| <b>Project Title:</b>   | Laurelwood Data Center (MECP I Santa Clara I, LLC)  |
| <b>Document Title:</b>  | ROC with SVP Laurelwood Data Center   |
| <b>Description:</b>     | Record of Conversation from Silicon Valley Power-response to questions on 7_2_19 (TN229077) |

**SUBJECT:** Siliocon Valley Power (SVP) Responses to Questions from Staff

| DESCRIPTION           |  | DATE           |             |
|-----------------------|--|----------------|-------------|
| SINGLE-LINE DIAGRAM   |  | SCALE          | DATE        |

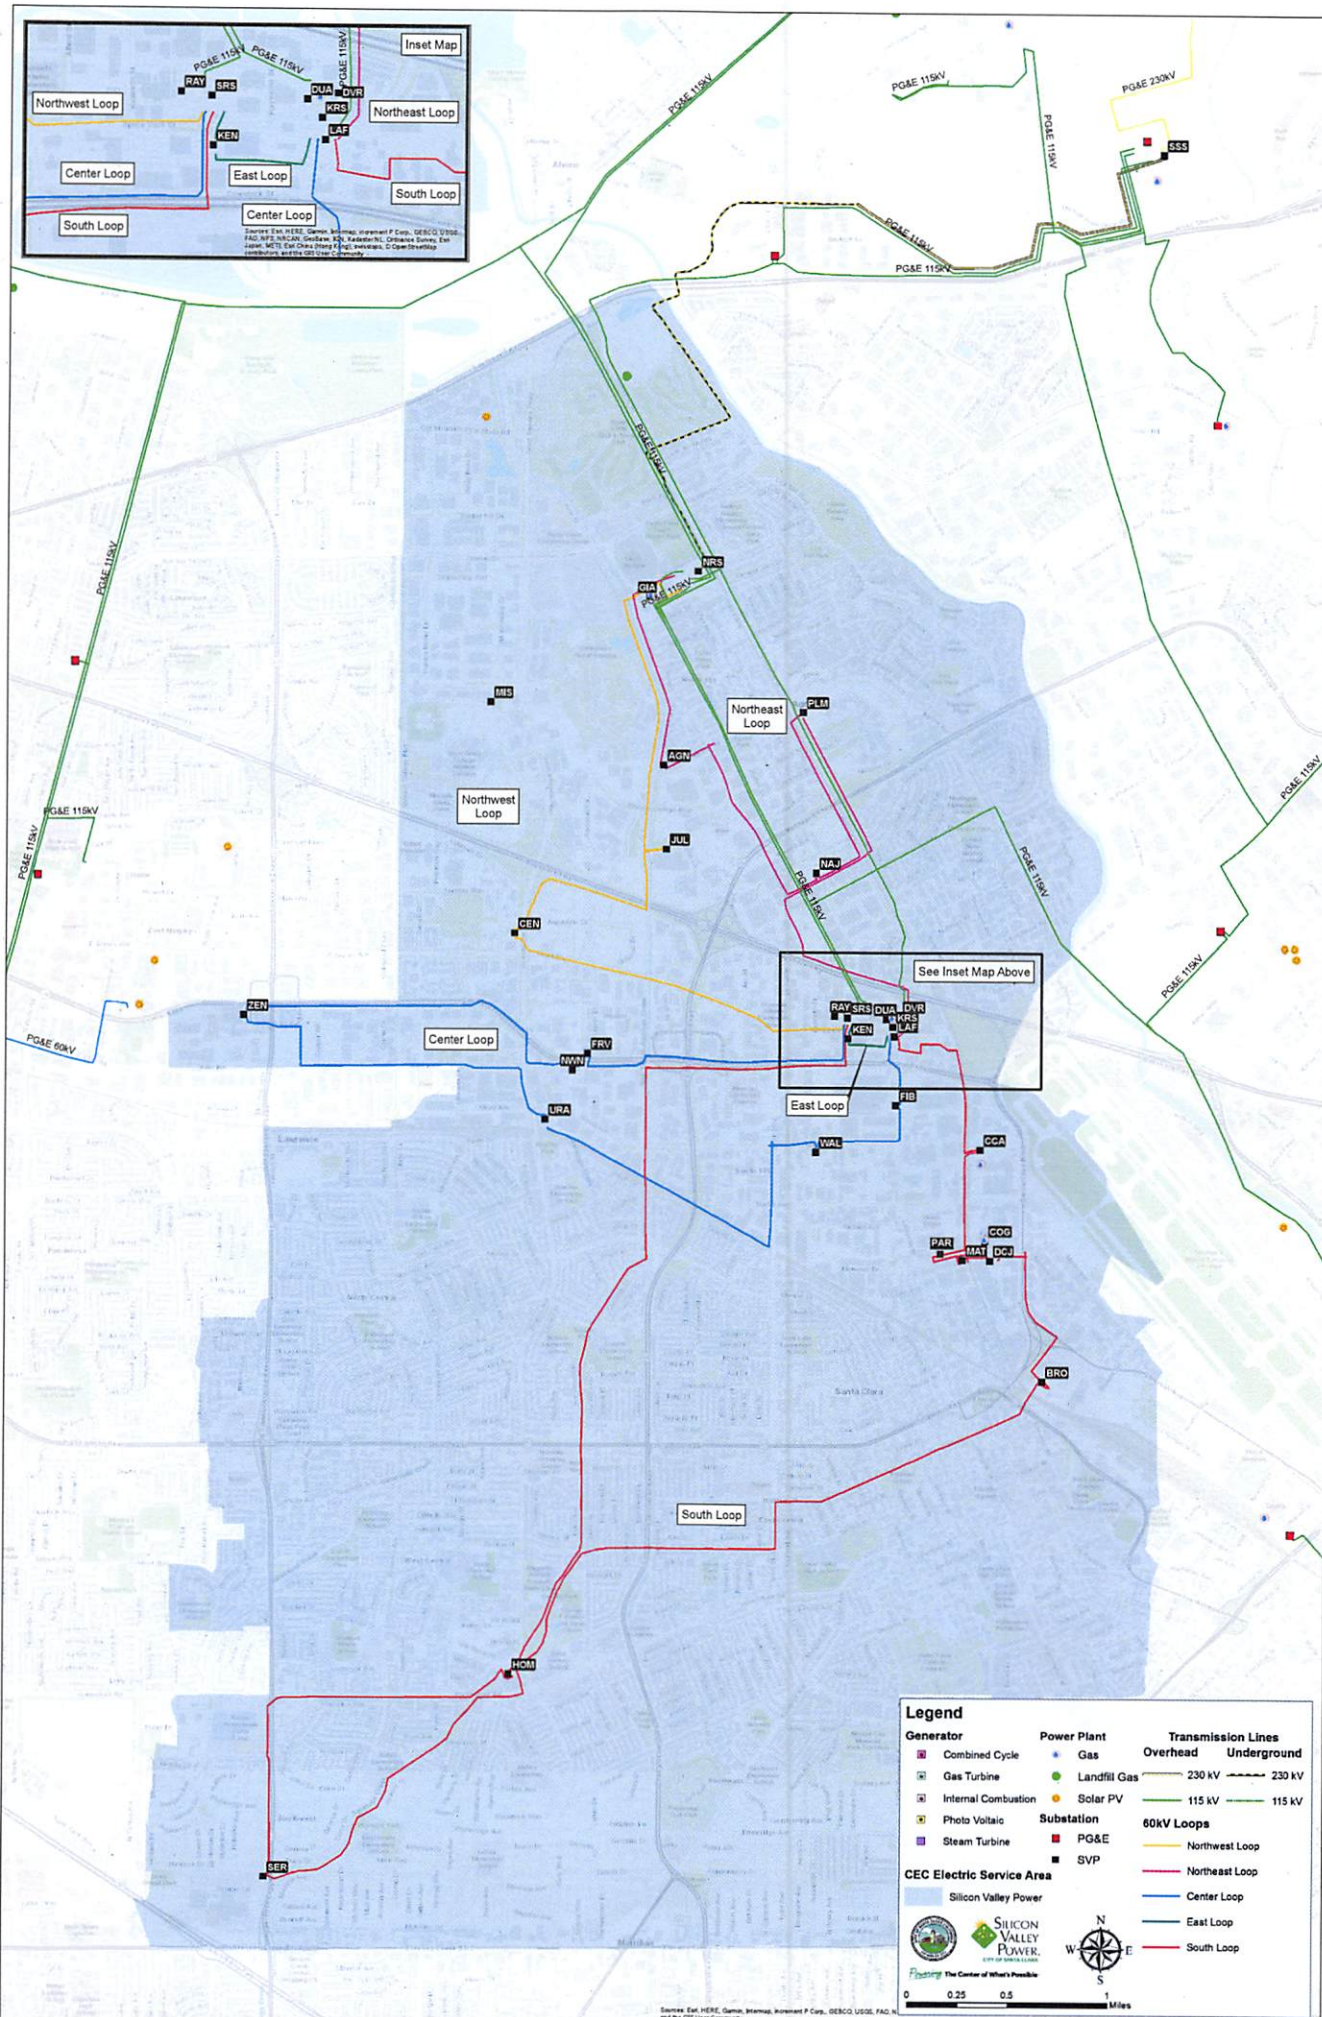
- a. A physical description

Laurelwood Substation is a three-50MVA (60kV:12kV) transformer bank substation on SVP's 60kv South Loop. It is located between our 115kV Kifer Receiving Station (KRS), and 60kV substation, CCA. Each Transformer has a rating of 30/40/50 MVA, IEEE max temperature rise of 65 C, increases the capability by 10% or 33/44/56 MVA. The final buildout of Laurelwood substation will have a capability of 100 MVA, with 150 MVA of installed capacity which increases its reliability. Laurelwood Substation Single Line Diagram XXX-E-0-X-1 is attached.

The Interconnection points to SVP will be the three low-side transformer gang switches currently drafted as GS30, GS20, and GS10.

There are four 60kV Breakers at Laurelwood, CB12, CB22, CB32 and CB42 which will enable various isolation schemes to insure a transformer bank can be isolated while the other two transformers remain in service. The system is designed such that one of the transformers can be taken out of service for repairs or maintenance while the other two can fully support customer load.
